11 October 2023

Interested party number: 20041317

#### BRAMFORD TO TWINSTEAD - WRITTEN REPRESENTATION

# 3.2 Historic Mapping:

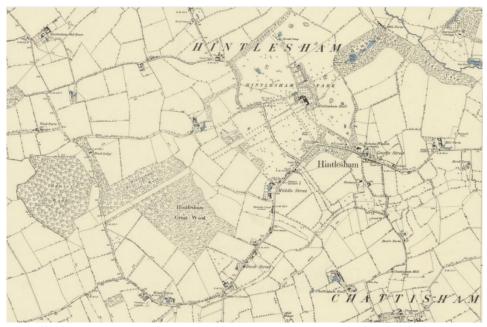
The park is shown on Hodskinson's map of Suffolk, 1783, on which the principal north/south driveway and secondary east/west driveway can be seen clearly. The east/west driveway is shown with a formal avenue of trees planted along it.

The first edition 25" to 1 mile Ordnance Survey map (surveyed 1881) shows looser tree planting in the vicinity of the east/west driveway, scattered parkland planting surrounding the Hall on all sides, and a belt of trees ('Square Pastures') to the west and north west of the Hall delineating the boundary between the parkland and the farmed landscape beyond. This tree belt is still largely intact, but a broken tree line survives only on the north side of the east/west driveway today.

Historically the view to and from the principal front was framed by an avenue of trees across the parkland and a long vista between Hintlesham Great and Hintlesham Little Woods, as shown on the OS 6" map (surveyed 1881 to 1884). The principal front of the Hall is still a significant feature in the landscape when viewed from the Hadleigh to Ipswich Road which lies to the south west.
